FUCHSIA AT HILLWOOD EAST SUBDIVISION

APPLICATION NUMBER 4 DATE June 17, 2021

REQUEST Subdivision

DETAIL SITE PLAN

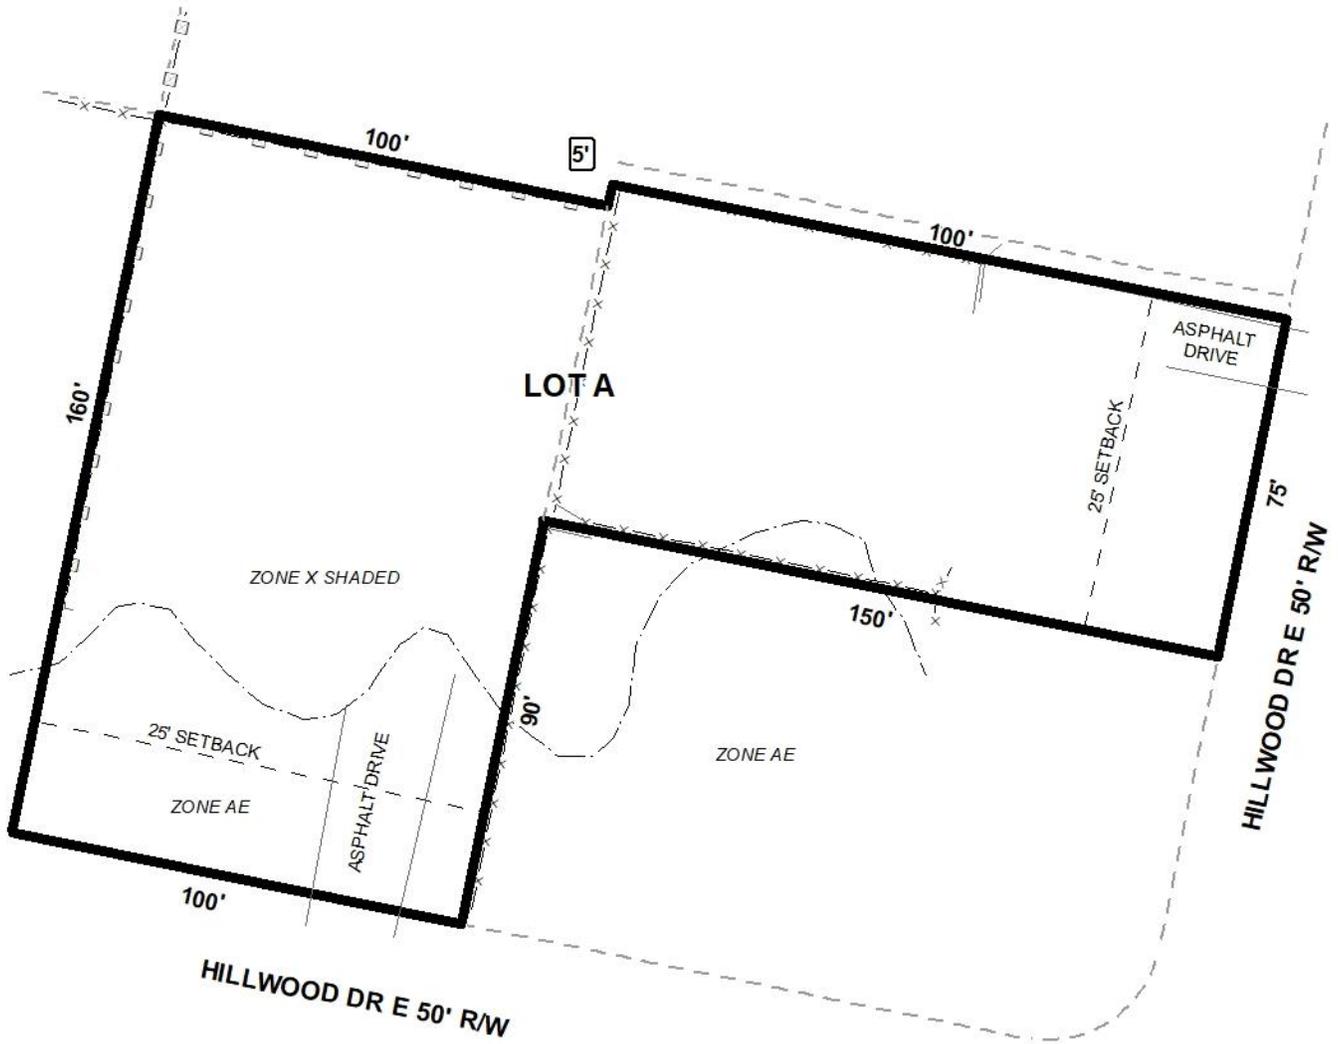
The proposed lot is “L” shaped with a double frontage on Hillwood Drive East, a minor street without curb and gutter, and therefore should have a 60’ wide right-of-way. The preliminary plat illustrates an existing 50’ right-of-way. As such, revision of the Final Plat and dedication to allow 30’ from the center line of Hillwood Drive East would typically be required. It is important to note however, that the subject site is included as part of the Edgewood Park subdivision originally recorded in 1948, 14 years prior to the adoption of the City’s Subdivision Regulations in 1962. The original recorded plat illustrates a 50’ right-of-way for Hillwood Drive East and it does not appear that there have been any other recent subdivisions of neighboring properties. As such, if approved, it may be appropriate to do so with sub-standard ROW widths and a waiver of Section V.B.14. of the Subdivision Regulations.

In regard to the irregular “L” shape of the proposed lot, it should be noted that Section V.D.1. of the Subdivision Regulations states that, “...the shape and orientation of lots...shall be compatible and appropriate to the location of the subdivision and the type of development and use contemplated. Panhandle or flag lots shall generally not be allowed, but may be permitted only in those locations where varied and irregularly-shaped lot designs are common and the informality of design is consistent with other lots in the vicinity...”. There do not appear to be any other irregularly-shaped lots in the area nor was any justification provided pertaining to use or contemplated development.

Furthermore, Section V.D.8. of the Subdivision Regulations states that double frontage lots will only be permitted where necessary to provide separation of residential development from major streets or to overcome specific disadvantages of topography and orientation. The Lot does not front a Major Street, City topographic records does not suggest any specific disadvantages, and no justification was provided detailing disadvantages to existing orientation.

The preliminary plat illustrates the proposed lot size as compliant provided in both square feet and acres and should be retained on the Final Plat. A compliant 25’ minimum building setback is illustrated along both frontages and should be retained on the Final Plat as well, if approved.

No easements are indicated on the preliminary plat. If any easements are recorded on the site they should be indicated and labeled on the Final Plat, and a note should be placed on the Final Plat stating that no structure may be placed or constructed within any easement without permission of the easement holder.

Based on the preceding, with waivers of Sections V.D.1., V.D.8., and V.B.14 of the Subdivision Regulations, this application is recommended for Tentative Approval subject to the following conditions:

- 1) If two (2) dwelling units exist on the proposed lot, removal of one of the units (with proper demolition permits) is required prior to signing the Final Plat;

- 2) Retention of the lot size in both square feet and acres, or the furnishing of a table on the Final Plat providing the same information;
- 3) Retention of the 25' minimum building setback along both frontages on the Final Plat;

- 4) Placement of a note on the Final Plat stating that no structure may be constructed or placed within any easement without the permission of the easement holder, if applicable;
